HMMWV...

# A TWIST ON BRAKE BLEEDER VALVE TORQUE

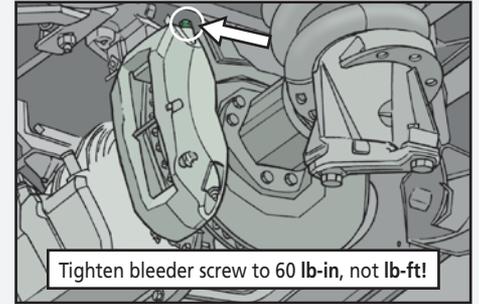
It's not just cereal that goes snap, crackle and pop. Every time I go to tighten a HMMWV's brake bleeder valve, it seems like I end up destroying it! I've followed every step in the TM, but Soldiers keep coming back to the shop with leaky or broken bleeder valves. How do we fix this problem?

The torque specification listed in TM 9-2320-387-24-1 instructs users to "Tighten bleeder screw to 60 lb-ft, or 81 newton meters" and TM 9-2320-387-24-2 lists the bleeder screw torque as "6-15 lb-ft, or 8-20 newton meters."

TACOM LCMC says that both TMs should read, "Tighten bleeder screw to 60 lb-in (7 newton meters)."

You should see this correction in the next TM change. Until then, make a note of the right torque in the following TM sections:

- TM 9-2320-387-24-1 (Page 7-4.3, Step 4, Paragraph 7-2.1 and Page 7-4.4, Step 5, Paragraph 7-2.1 of Change 6)
- TM 9-2320-387-24-2 (Page 22-10, Step 16, Paragraph 22-5 of Change 1)
